# SITE BASED STORMWATER MANAGEMENT PLAN

Proposed Developments at  
62 KRAFT RD, 69 & 73 KRAFT RD AND 136 & 152 LAXTON RD PALLARA  
for  
ADC GROUP NO 12 PTY LTD & ADC GROUP NO 15 PTY LTD

B3602EA7\_DA19\_SBSMP – Revision C  
May 2026

Revision	Date	Details	Prepared By	Approved By
A	29/08/2022	For Client Review & Authority Submission	CB (RPEQ 19190)	TMcK (RPEQ 5087)
B	28/07/2025	Revised development strategy	CB (RPEQ 19190)	TMcK (RPEQ 5087)
C	08/05/2026	Council Information Request Responses	 CB (RPEQ 19190)	 SM (RPEQ 8068)

Figure 2 – Proposed Field Inlet (Schematic Only)

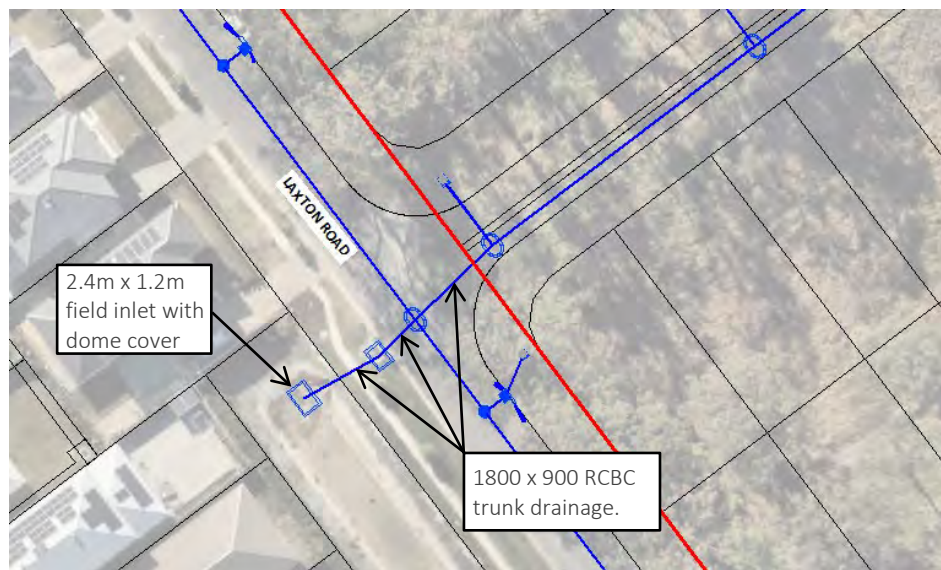
6. *Flood model must be amended to include:*
- *The trunk pipe on Laxton Road must connect to the existing concrete channel via a new large inlet to capture as much of the 10% AEP flow as possible. Provide model inlet capture details on that inlet.*

- *The impact on Laxton Road as a result of this development needs to be reduced as the access to the site is through this road connection. This road should provide a suitable standard of service. A new inlet may help reduce the impacts.*

- A field inlet with a minimum 2.4m x 1.2m opening is proposed at the end of the existing concrete channel. Refer to **Appendix I** for inlet capture modelled and **Figure 2** for the schematic.
- The results showed improvements on Laxton Road in a 10% AEP however it did not notably reduce the flood level impacts in a 2% AEP storm event. Still, the 2% AEP flooding on Laxton Road complies

with the QUDM (2016) as the flood depths do not exceed 300mm and DV products do not exceed  $0.4\text{m}^2/\text{s}$ . Refer to **Section 4.4.4** for further details.

Figure 13 – XP-STORM Layout (Ultimate Scenario)

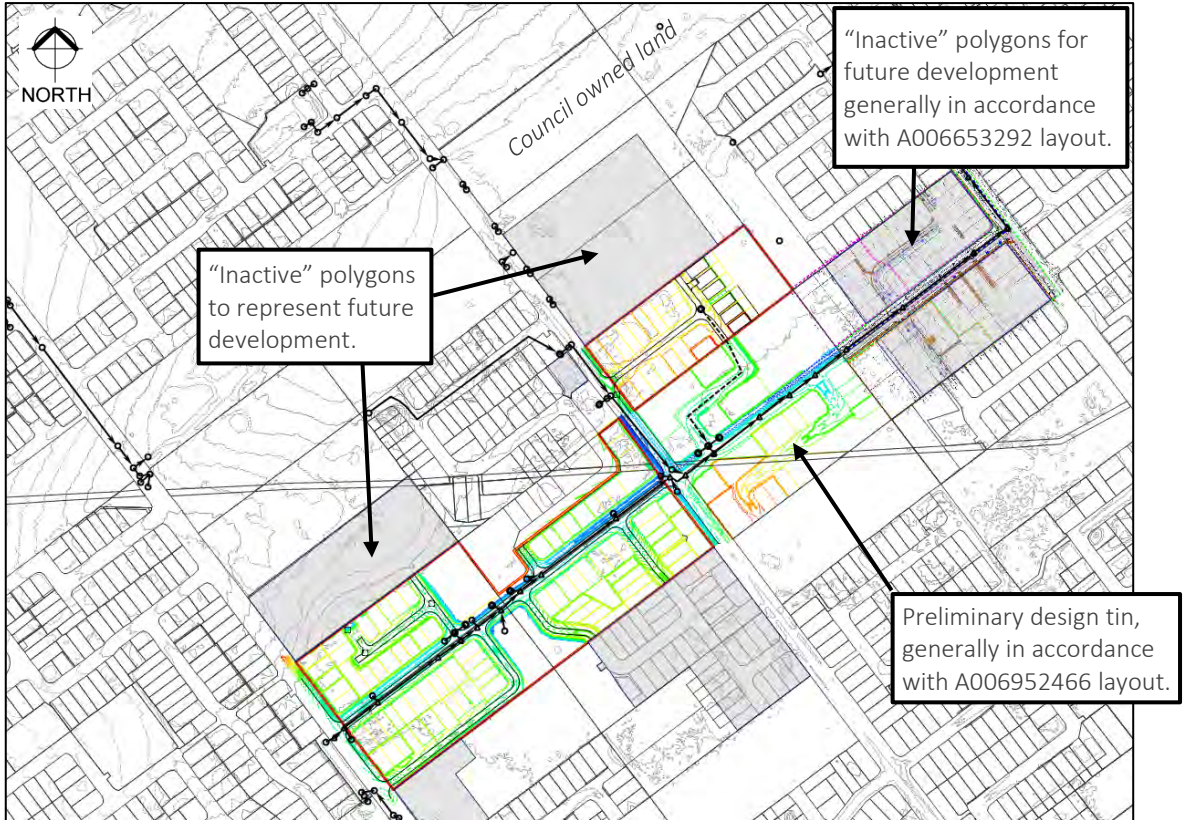
- *Figure 9 in Flood Study shows inactive polygons over Council owned 38 Kraft Road. This area should not be assumed to be filled in the modelling as this is park/ environmental area. Additionally, polygons on the 121 and 97 Sweets Road developments should be consistent with that proposed in development proposals.*

- The inactive polygons over Council owned 38 Kraft Road has been removed and the polygons on 97 & 121 Sweets Road amended to align with their development proposals. Refer to **Section 4.5**.
- Additional sensitivity scenarios have been included, as presented in **Section 4.6**, including allowance for climate change provisions by adopting a 20% increase in 2% AEP rainfall intensities. The results confirm that the new lots remain flood free.

Figure 16 – Sensitivity Scenario 1, 2% AEP Overland Flow

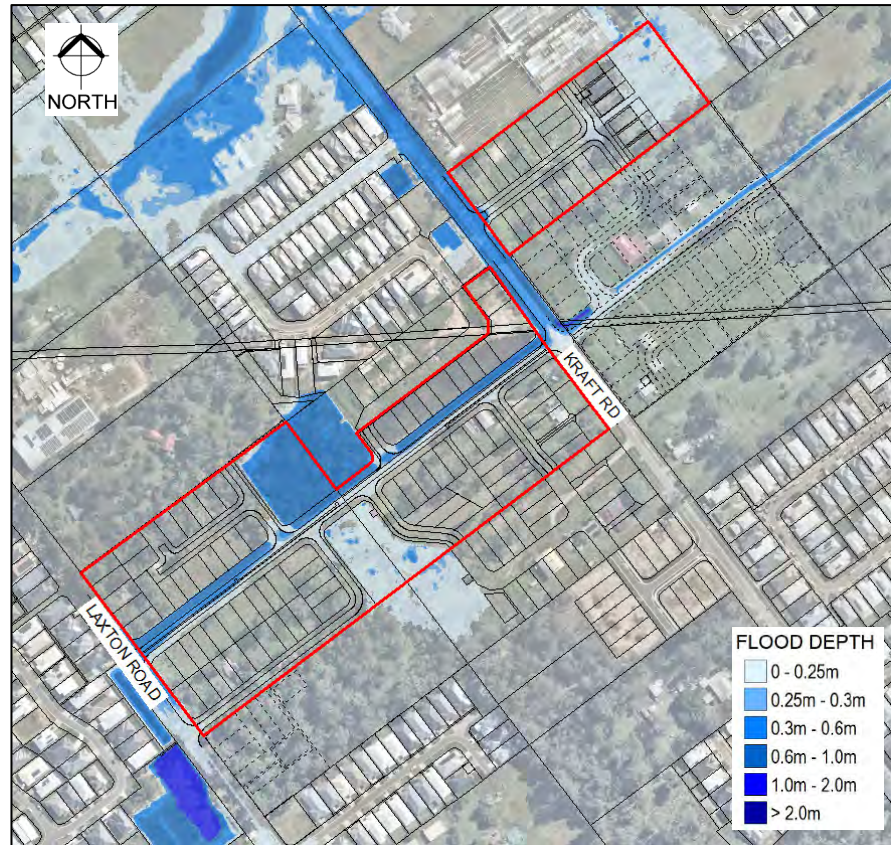
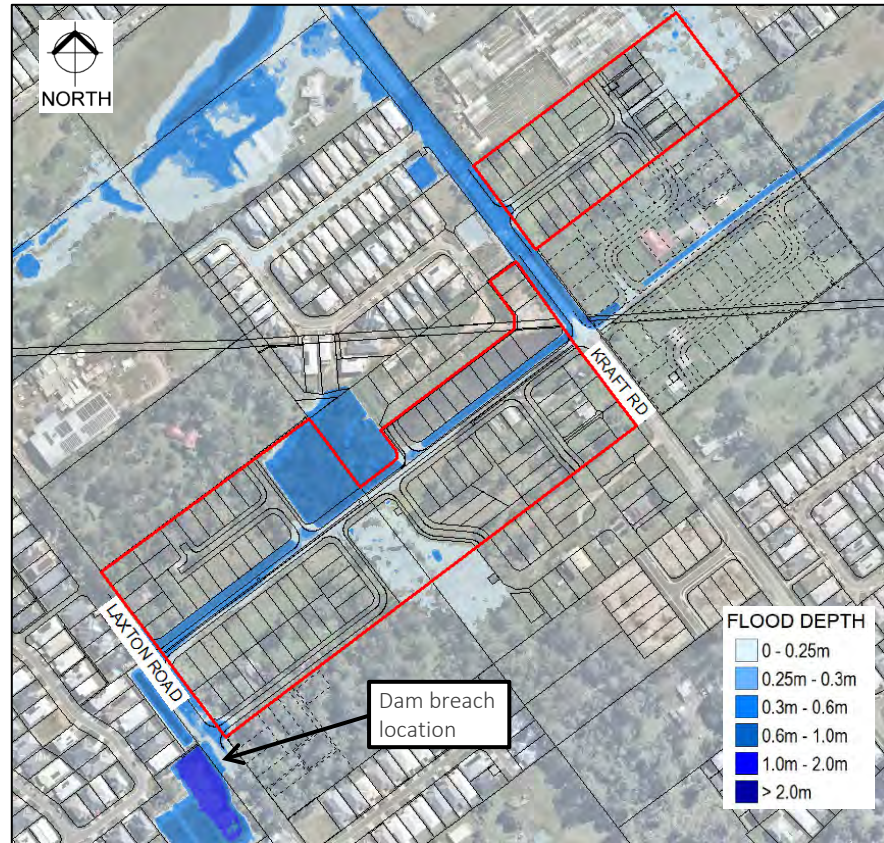
- *The sensitivity scenario shall include AR&R climate change provisions, especially as it is downslope of a dam. This could be a simple factoring up of 1987 IFD used in the hydrology*

1. *The flood analysis sensitivity scenario is required to include AR&R climate change provisions, especially as it is downslope of a basin. This could be a simple factoring up of the 1987 IFD used in the hydrology in accordance with SSP2-4.5. It must be ensured that new lots do not flood as a result of this sensitivity scenario. In addition, sensitivity analysis should include the risk to adjacent lots on Laxton Road and lots along the new neighbourhood road in the case of a dam failure.*

**RESPONSES TO ITEM 1:** Refer to **Section 4.6** for the 2% AEP sensitivity scenarios. The results confirm that the new lots remain flood free with climate change provisions. The results further confirm that the new lots on Laxton Road remain flood free in the case of a dam failure.

The 2% AEP flooding is shown on **Figure 16** and **Figure 17**. As can be seen all new lots remain flood free. It is further noted that the applicant's typical slab height for lots is 450mm. The dwellings will therefore have well above the minimum freeboard required.
